Origination Form
Proposed Revisions to a Standard Plans Index

Originator:	Gray, Ryan	Index Number:	546-001
Date:		Sheet Number(s):	1 and 2
E-mail:	ryan.gray@dot.state.fl.us	Index Title:	RAISED RUMBLE STRIPS

Sheet 1: Added text to thickness dimension, Updated text for, and Deleted obsolete text for OPTION P2; Updated Note 2; Added Note 3.
Sheet 2: Added text to thickness dimension for OPTION ST2; Updated text for OPTION ST2 and OPTION S3; Updated Note 3; Added Note 4.

OPTION P2 - PREFORMED THERMOPLASTIC SET

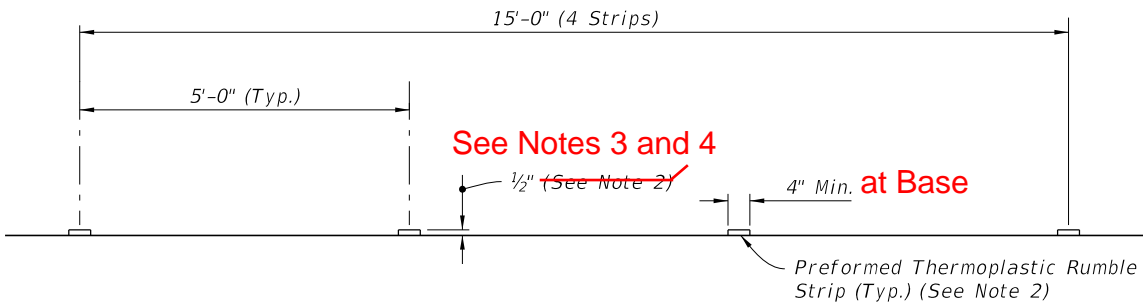
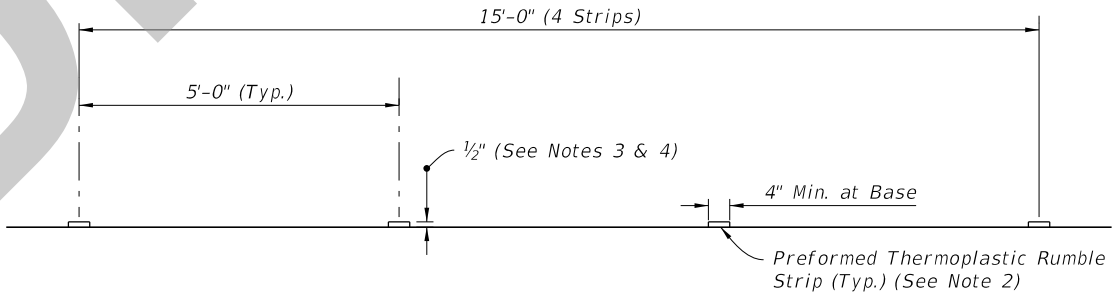
- NOTES:
- Construct permanent raised rumble strips where shown in the Plans and in accordance with Specification 546.
 - Use ~~color~~ **colors** white for preformed thermoplastic rumble strips. **or black**

Added Note: 3. The rectangular rumble strip shown is an example only; profile may vary in accordance with the manufacturer's design as shown in the APL.

Added Note: 4. Total pre-installation height of product (as approved on the APL).

- NOTES:**
- Construct permanent raised rumble strips where shown in the Plans and in accordance with Specification 546.
 - Use colors white or black for preformed thermoplastic rumble strips.
 - Rectangular rumble strip shown as an example only; profile may vary in accordance with the manufacturer's design as shown in the Approved Products List (APL)
 - Total pre-installation height of product (as approved on the APL).

OPTION ST2 - PREFORMED THERMOPLASTIC SET

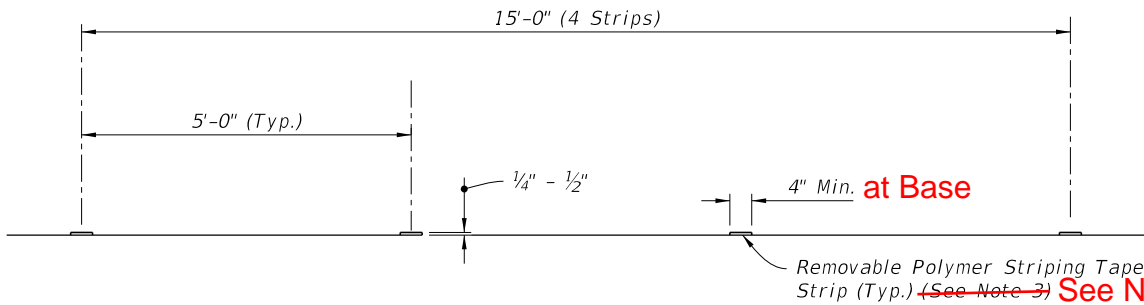
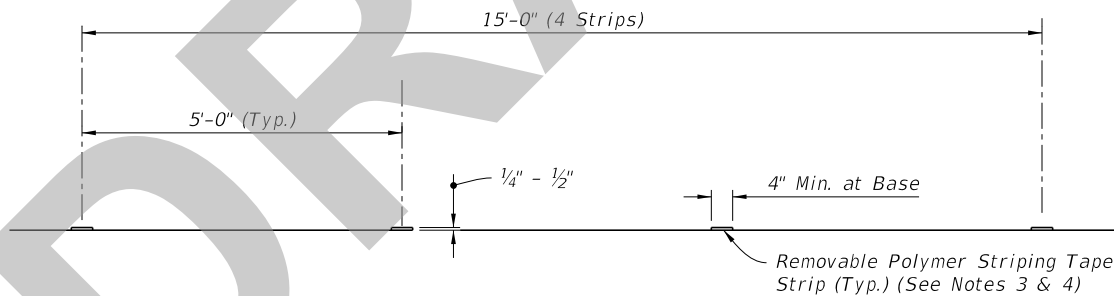
- NOTES:
- 1. Construct short-term raised rumble strips where noted in the Plans and in accordance with Specification 546.
 - 2. See Sheet 1 for placement and additional details.
 - 3. Use ~~color~~ white for Preformed Thermoplastic and Removable Polymer Striping Tape Sets.

Added Note: 4. The rectangular rumble strip shown is an example only; profile may vary in accordance with the manufacturer's design as shown in the APL.

1. Construct short-term raised rumble strips where noted in the Plans and in accordance with Specification 546.
2. See Sheet 1 for placement and additional details.
3. Use colors white or black for Preformed Thermoplastic and Removable Polymer Striping Tape Sets.
4. The rectangular rumble strip shown is an example only; profile may vary in accordance with the manufacturer's design as shown in the APL.
